Subject: Byron Station Units 1 and 2
Braidwood Station Units 1 and 2
Notification of Bases Changes to the
Technical Specifications
NRC Docket Nos. 50-454/455 and 50-456/457

ATTACHMENT A
SUMMARY OF PROPOSED CHANGES

FIGURE 1

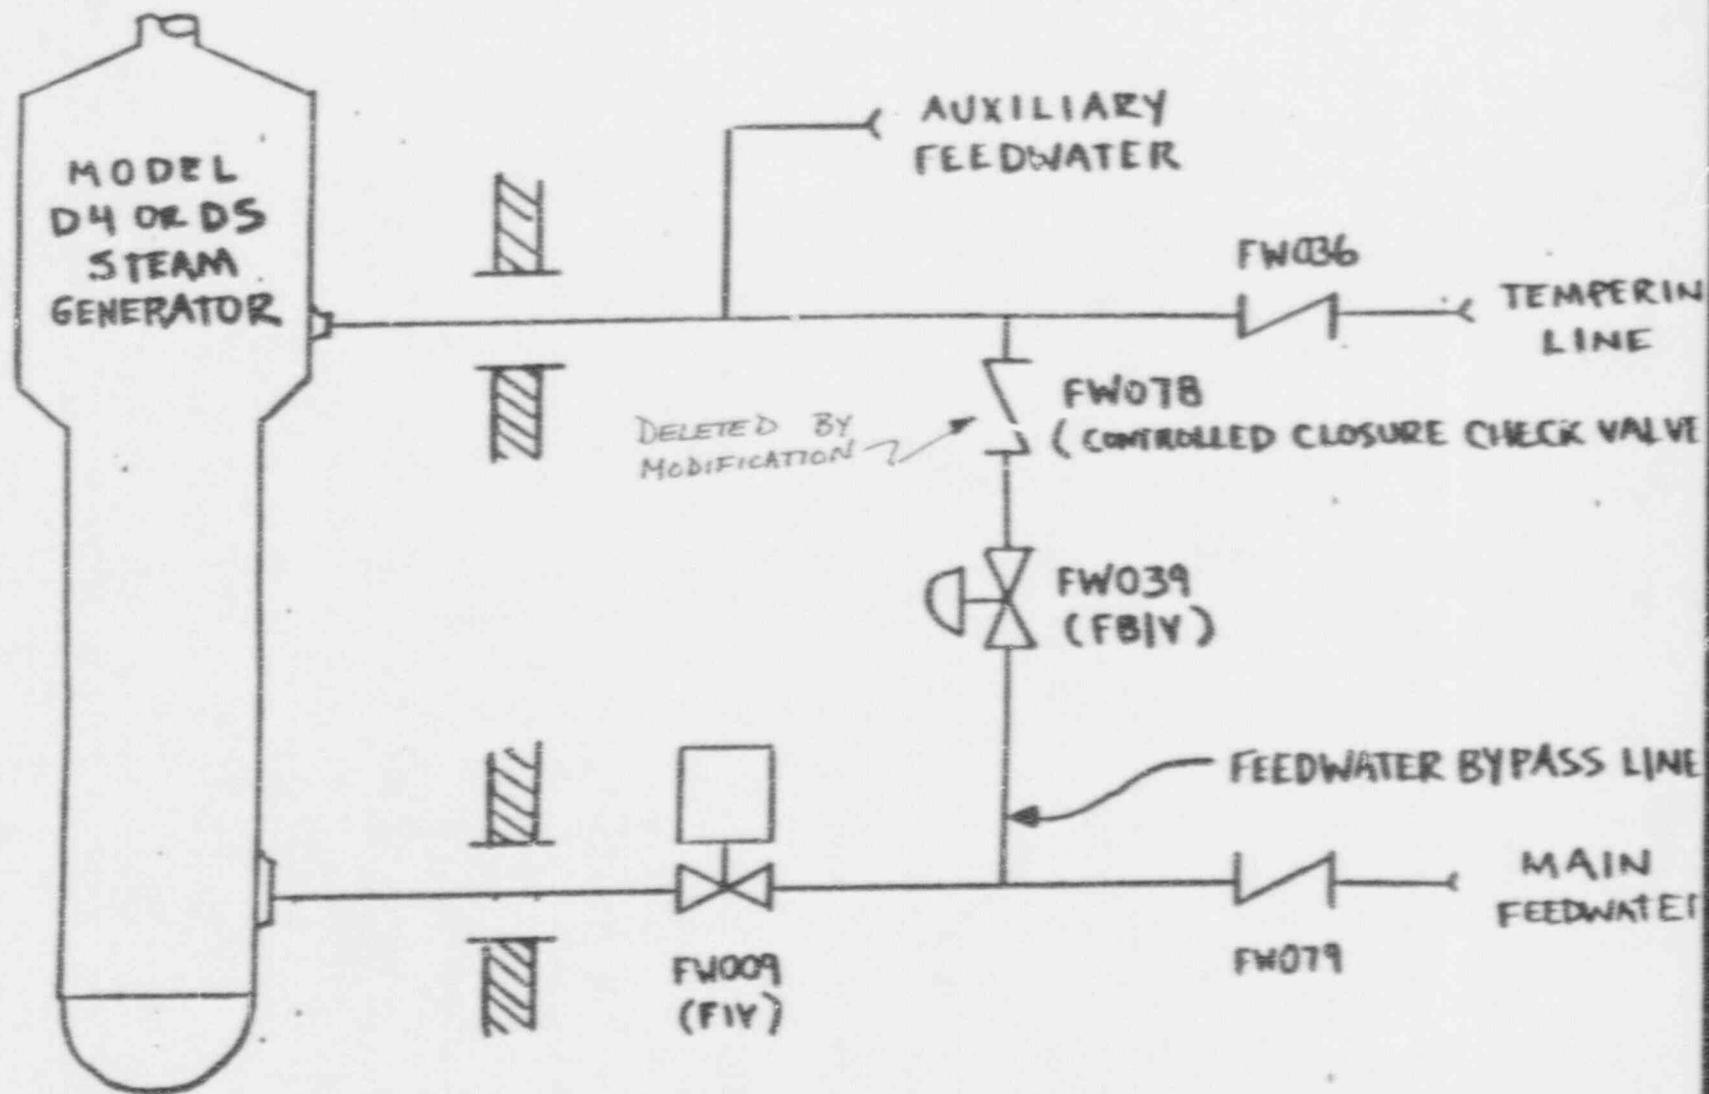
This bases is being changed to delete the reference to a Low T-ave signal in the discussion of the actuations associated with the P-4 interlock. The modification performed affecting this bases involved the removal of the check valves in the feedwater bypass lines to optimize the feedwater flow distribution between the upper and lower nozzles under full power conditions. This modification also deleted the Low T-ave input to the Feedwater Isolation logic, such that a Feedwater Isolation signal is generated with any P-4, or Reactor Trip signal. The previous configuration generated the Feedwater Isolation only if the P-4 signal existed coincident with a Low T-ave signal. The purpose of removing the Low T-ave input is to ensure a Feedwater Isolation on all Reactor Trips. This would protect the steam generator preheater section from water hammer due to the introduction of cold Auxilliary Feedwater into the preheater. With the feedwater bypass line check valves removed, a flowpath from the tempering line to the main feedwater line via the feedwater bypass line was created, absent prompt operator action to manually close the bypass line isolation valve. The modification ensures the preheater will be protected from waterhammer due to cold Auxilliary Feedwater flow automatically upon receipt of a Reactor Trip signal. A simplified diagram of the feedwater arrangement is attached.
